Waverley Council

AGENDA

I-1205.2.1 PAGE 4
310-330 Oxford Street, Bondi Junction – Modification to add two (2) additional storeys to an approved multi storey mixed commercial / residential development (DA 598/2008/E)

Section 96 Assessment Report	
Development Application No.	**DA-598/2008/E**
Address	310-330 Oxford Street, Bondi Junction
Section 96 Lodgement Date	5 December 2011
Proposal	Modification to add two (2) additional storeys to an approved multi storeys mixed commercial/residential development.
Approved Development	* Demolition of existing buildings and erect 10 storeys mixed development * Modification for two additional storeys
Zoning and relevant controls	• Waverley Local Environmental Plan (Bondi Junction Centre) 2010 • Waverley Development Control Plan 2010
Owner	Treesol Holdings Pty Ltd
Applicant	Elia Lies
Submissions	Twenty-four (24) objections and eighty four (84) pro-forma letters of support
Issues	floor space, height, extension of area to adjacent land at 308 Oxford St and integrity of new LEP controls
Recommendation	Refusal

DRAWING	L 12 & 13 RESIDENTIAL	DRAWN BY	MH/LG
		JOB NO	777
PROJECT	NOBLEWOODS	DRAWING NO	DA 01.29
	310-330 OXFORD ST. BONDI JN, NSW, 2026	REVISION	L

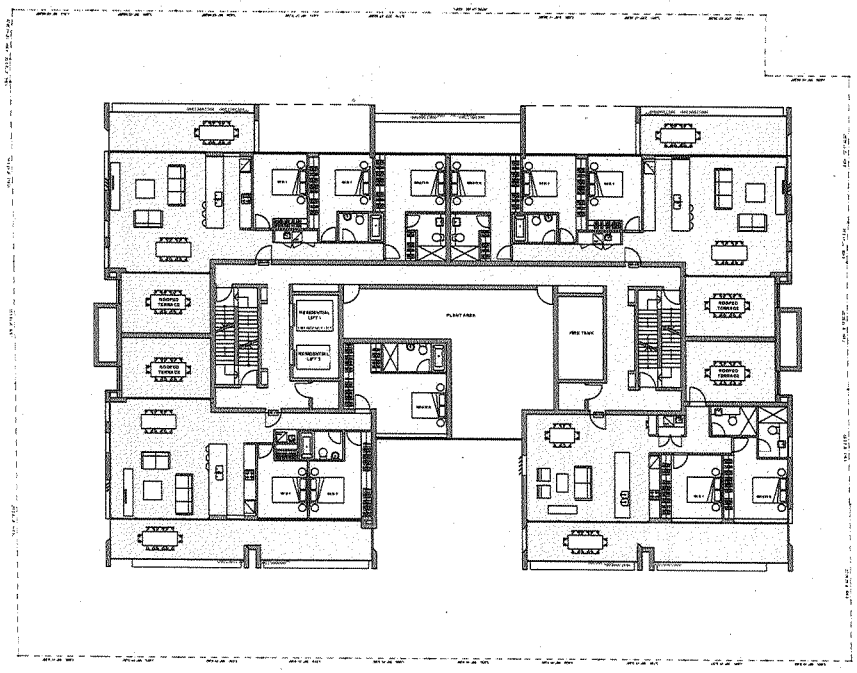
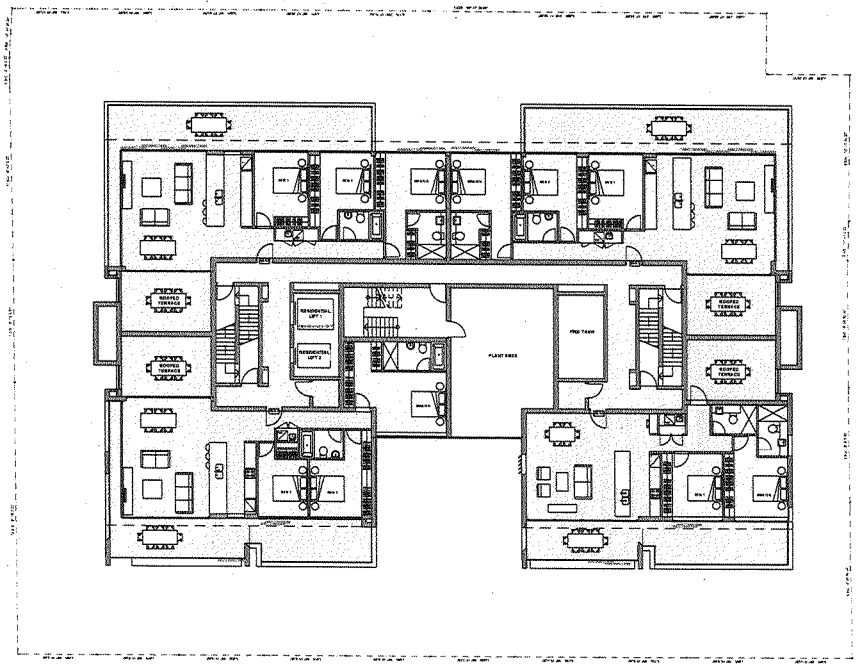
Number of storeys
The proposed modification results in additional levels over and above what is permitted under the DCP. As this amended proposal (to a total height of 44.50m) is above the 38m maximum height limit and the maximum 5:1 FSR control, this non-compliance in respect to number of storeys control is not supported.

4. The proposal does not satisfy Part F1 of the Waverley Development Control Plan 2010 in that the development would results in additional storeys / levels over and above what is permitted.

DRAWN BY	MH/LG		
DRAWING	SITE & ROOF PLAN	JOB NO	777
PROJECT	NOBLEWOODS	DRAWING NO	DA 01.16
	310-330 OXFORD ST, BONDI JN, NSW, 2026	REVISION	L

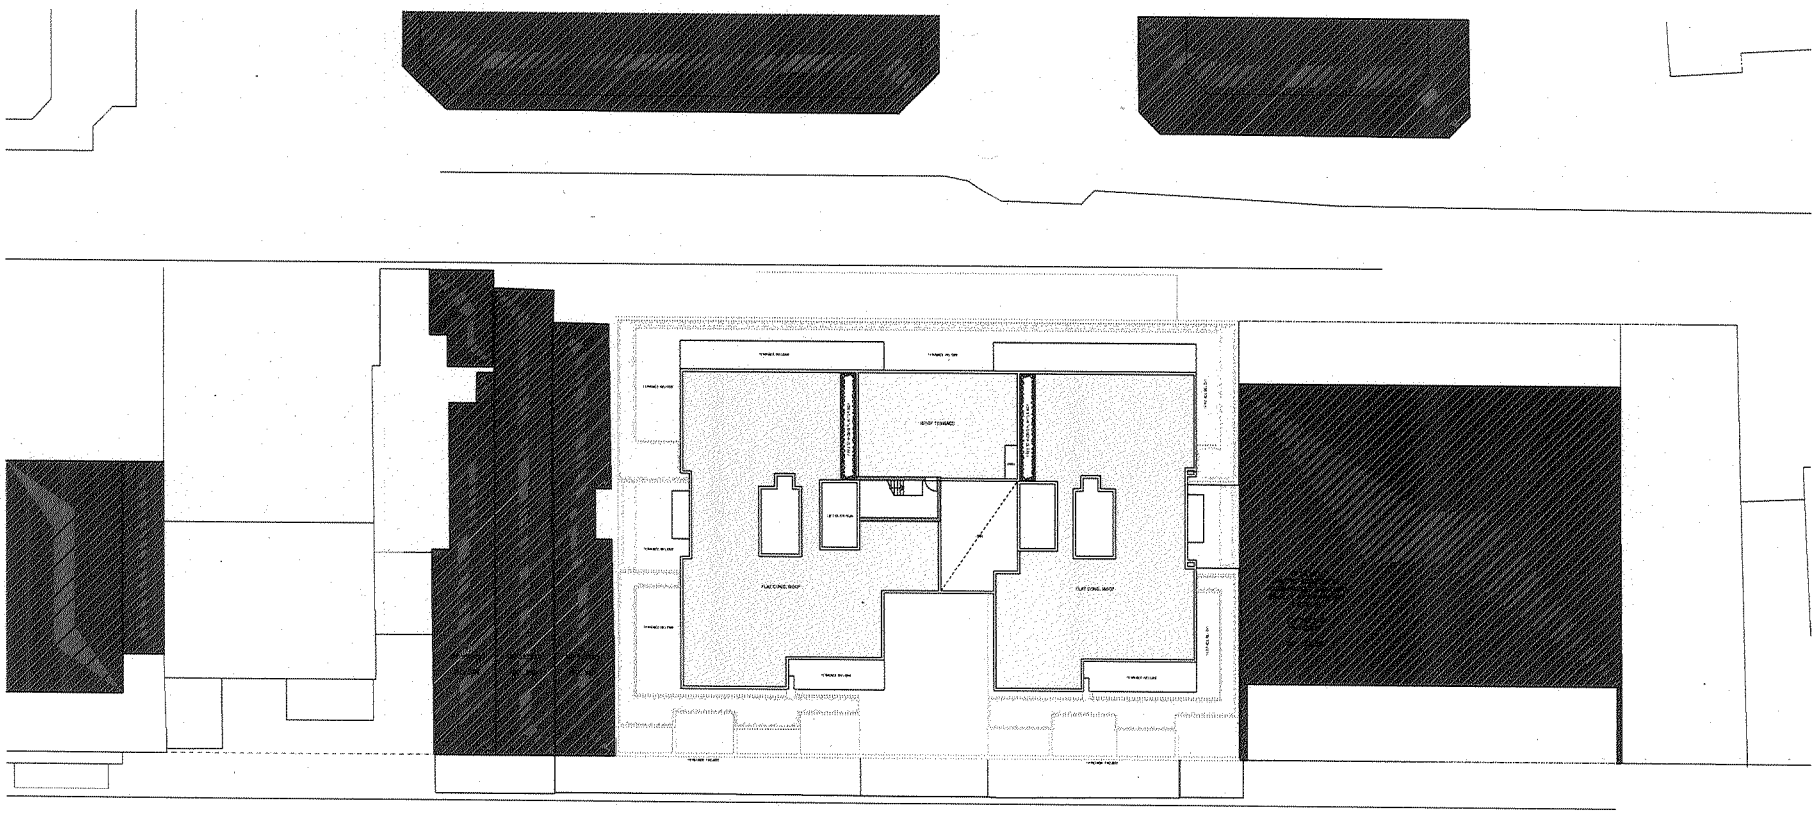
Roofline (motor and plant rooms)
The lift overrun is positioned on the roof (amendments to roof plan) and is not considered acceptable as it should be enclosed within the building envelope.

5. The proposal does not satisfy Part F1 of the Waverley Development Control Plan 2010 in that the lift overrun is positioned on the roof (amendments to roof plan) and is not considered acceptable as it should be enclosed within the building envelope.

EAST ELEVATION
1:100

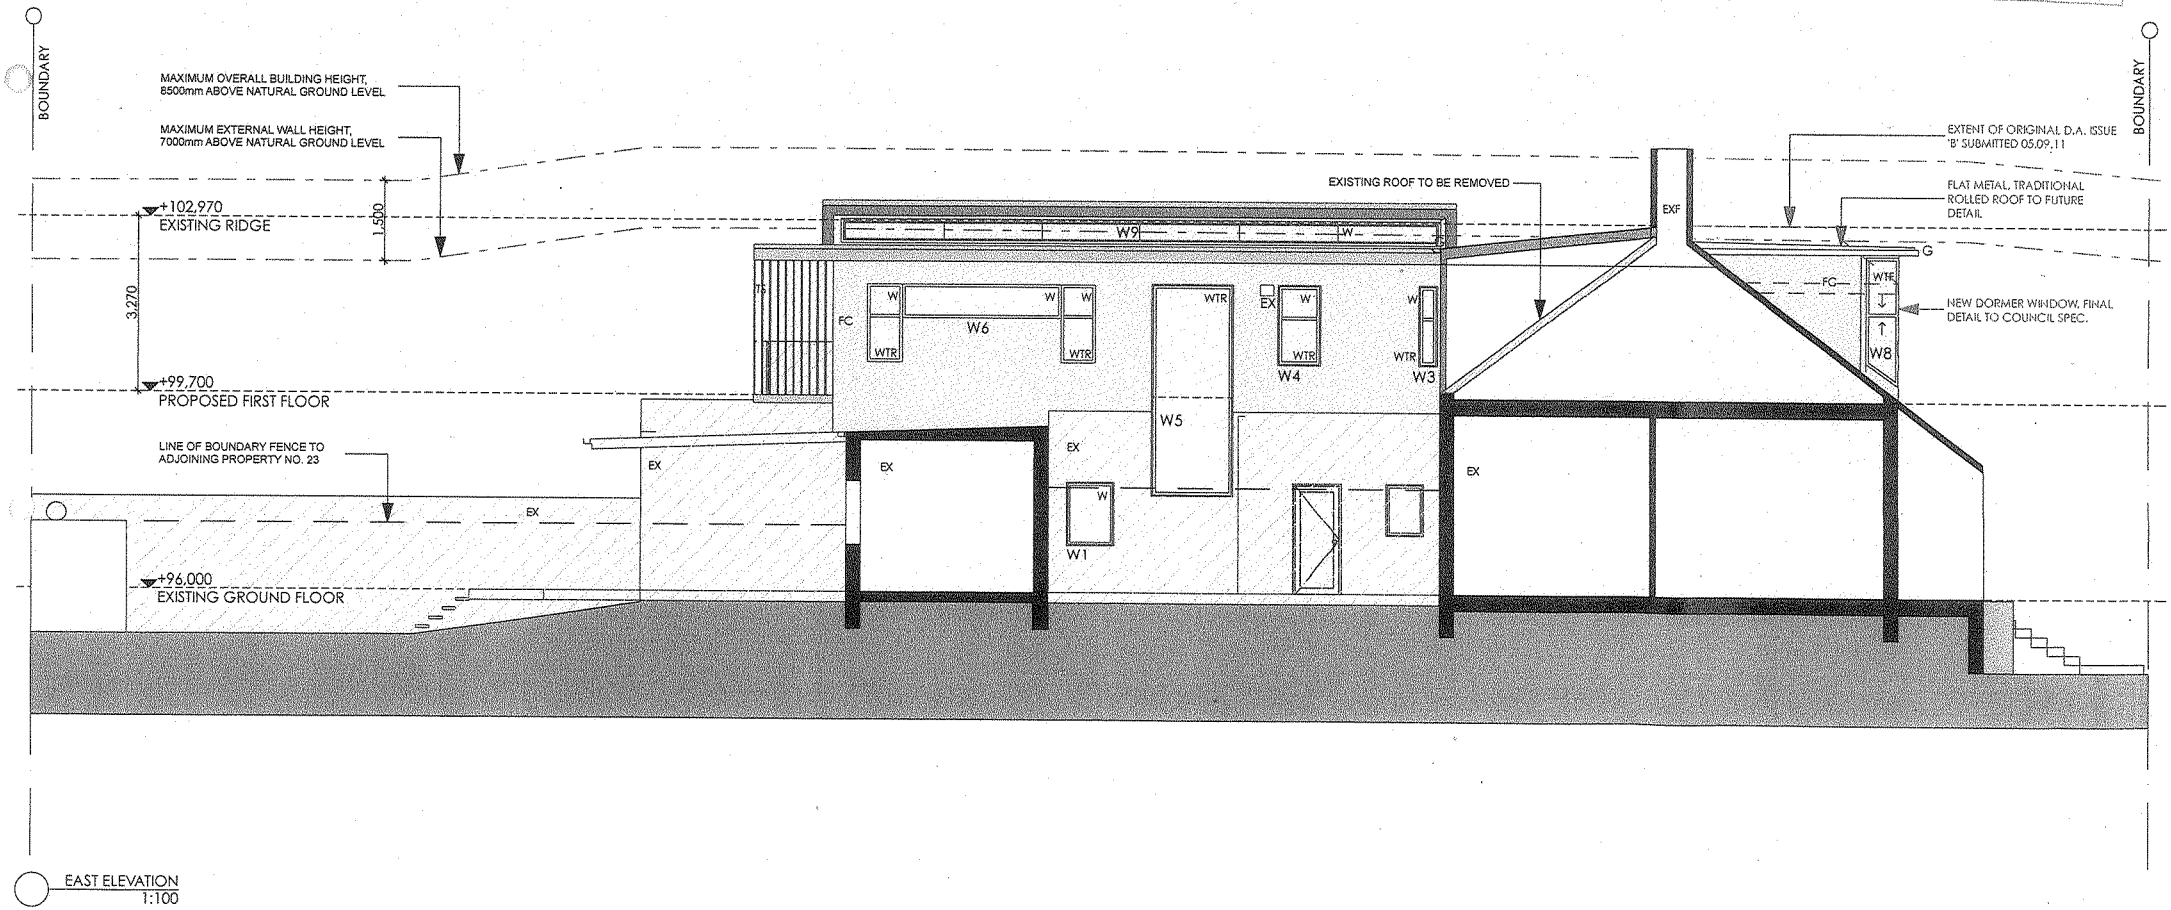
The proposal will contain a dormer window on the front elevation. The design of the dormer has been amended since it was initially submitted to provide greater cohesion with the Federation style of the dwelling. Further amendment is required by Council's Heritage and Urban Design Architect to further refine the design of the front dormer with the following works being required via condition:

- The extended eaves of the proposed dormer have tapered corners following the external wall plan of the dormer.
- Cladding to the dormer cheeks is of expressed weatherboard and not flat sheet fibre cement.
